SIGN TYPE:
**WFR2-M-22
PSCO WF_R2_MON_M22**

Client:	WELLS FARGO	Date:	03.26.24
Address:	3001 78TH AVE SE	Job Number:	
City:	MERCER ISLAND		
State:	WA 98040		
City Lights Sign Company	902 NW 49th St Seattle WA 98107 Ph: 206-789-4747 Cell: 206-255-7029

WELLS FARGO MONUMENT SIGN

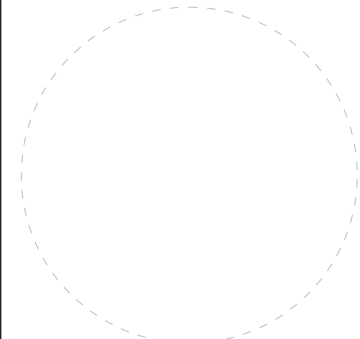
**MONUMENT SIGN
NO LONGER
PART OF SCOPE.**

**RETROFIT EXISTING
SIGNS ONLY**

NO LONGER

PART OF SCOPE.

RETROFIT EXISTING

SIGNS ONLY
